NORTH CENTRAL HIGH SCHOOL, PHASE 2

Addendum 2

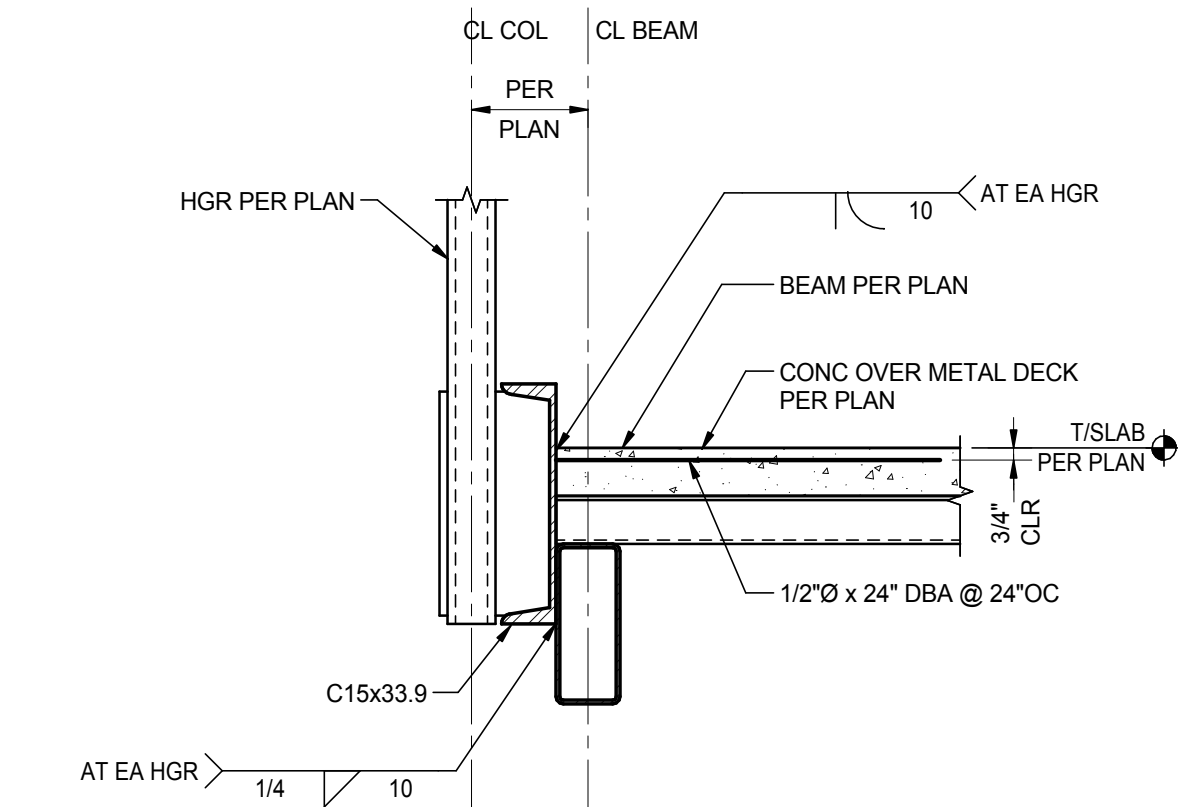
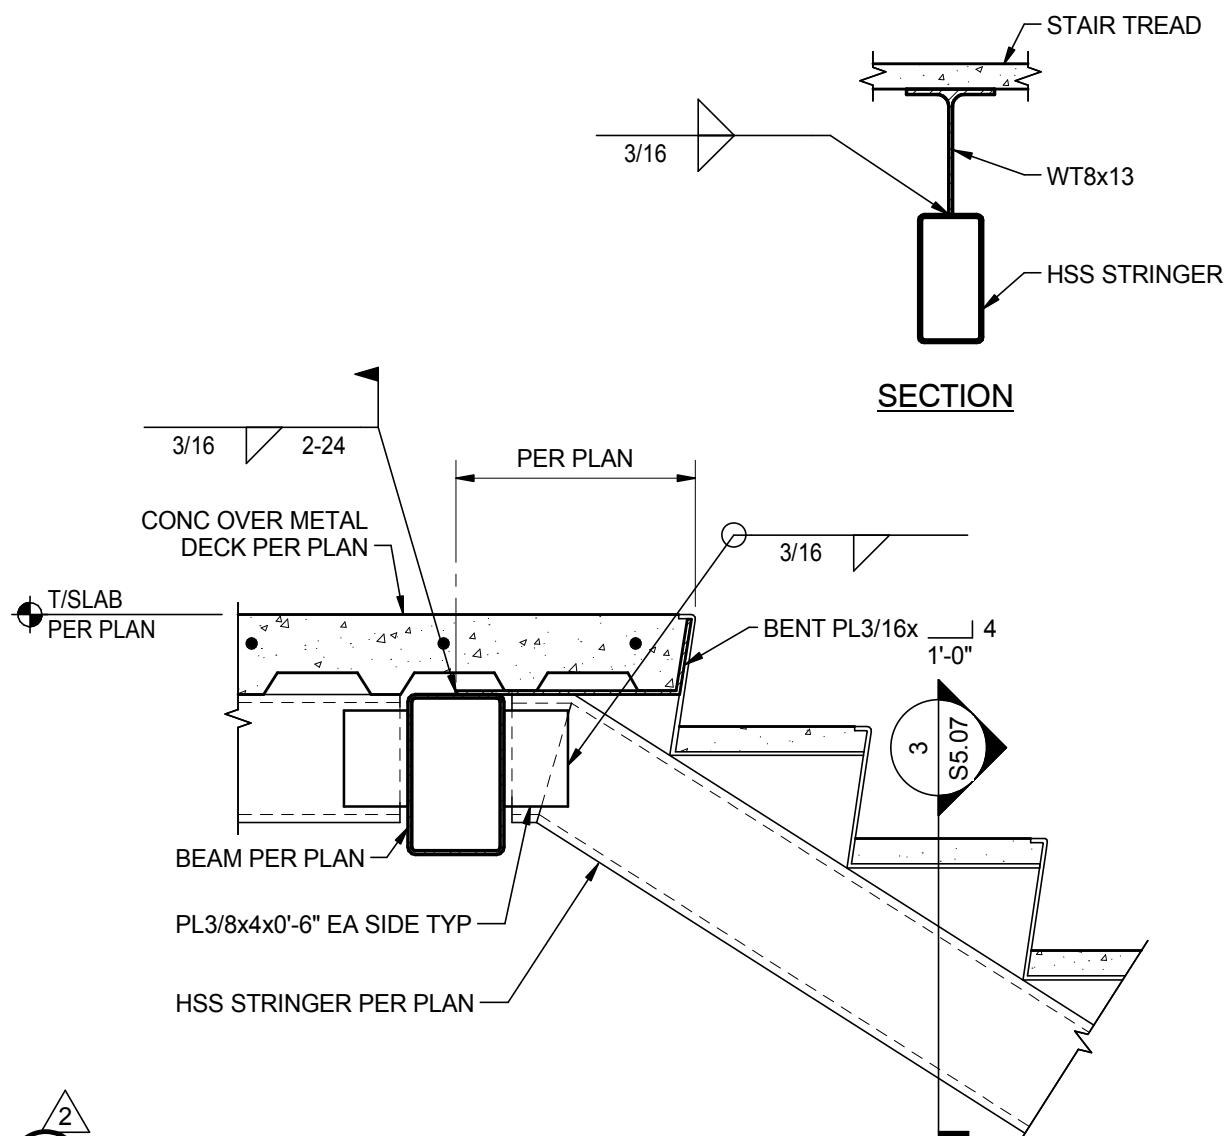
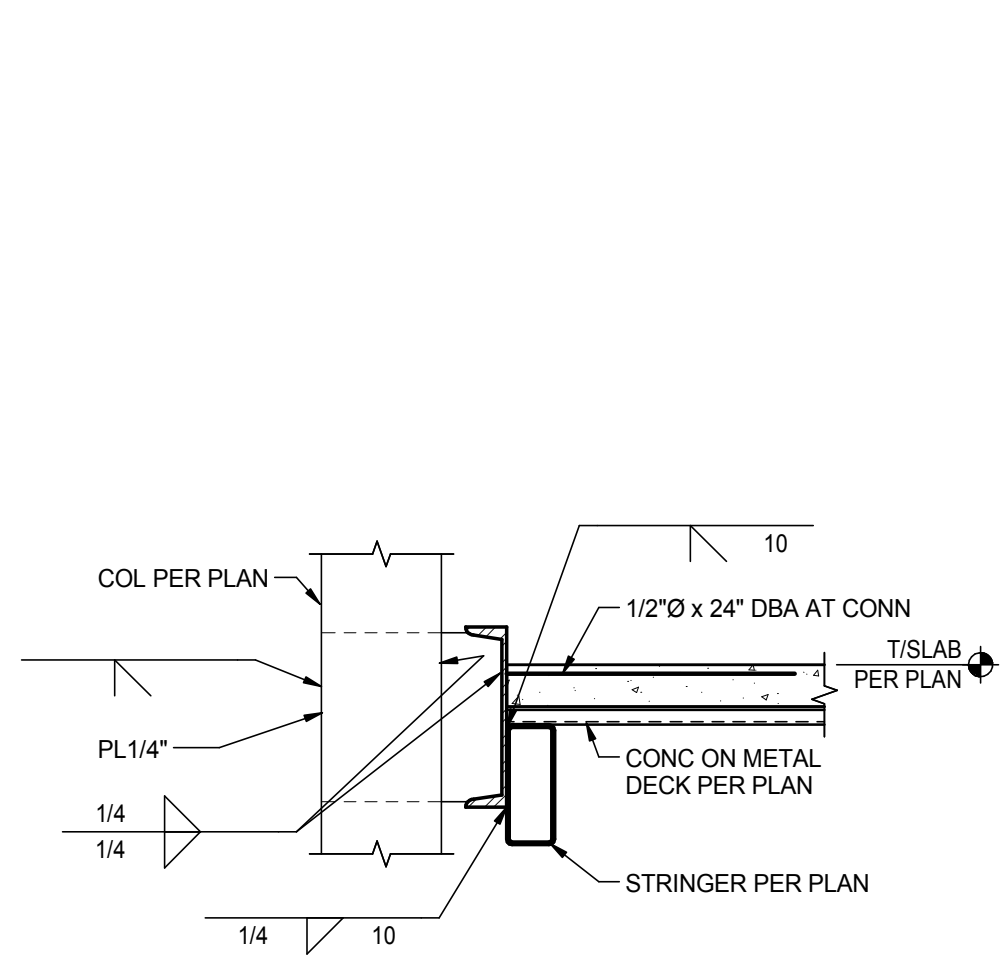
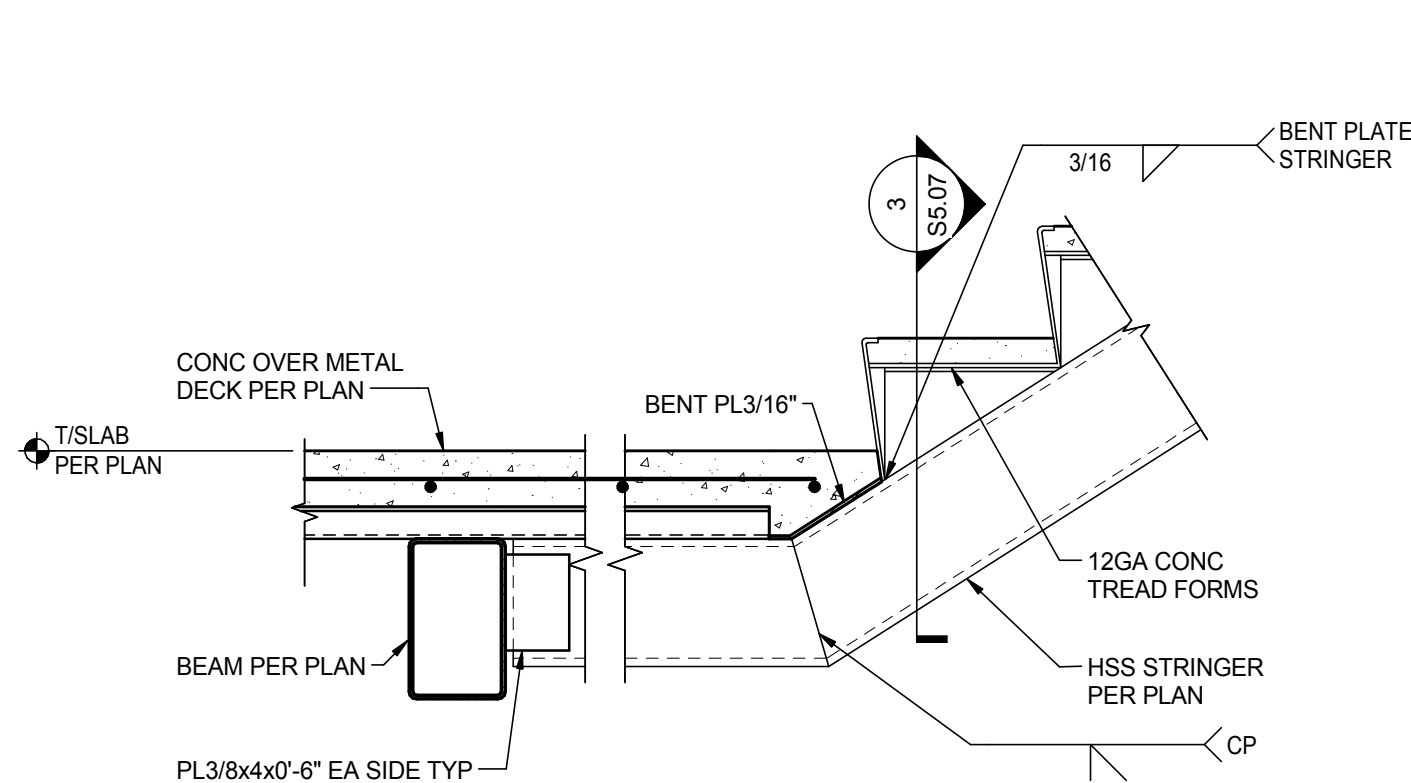
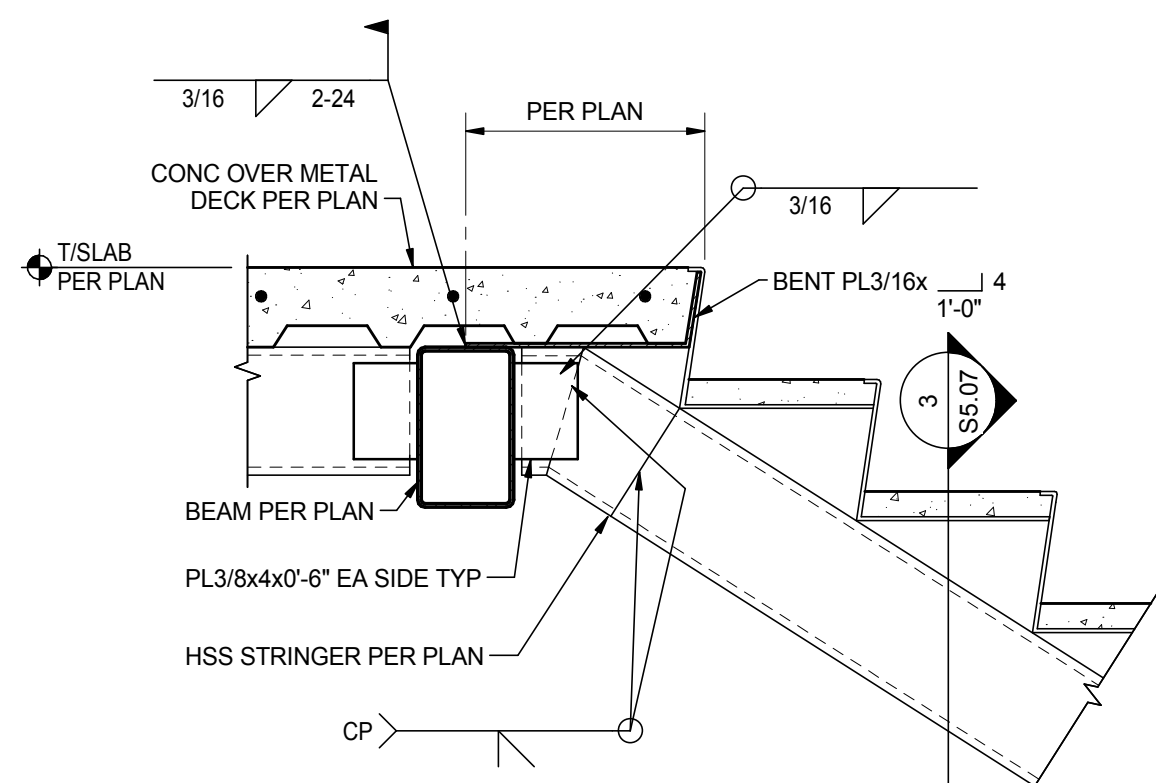
SHEET S5.07, FRAMING DETAILS:

ADD: Detail 1-4, 6 & 7 Stair details. Detail 10 Veneer support detail. Detail 15 Screen wall @ grid E4. Detail 19 Slab at seismic joint. Detail 20 CMU Wall Infill.
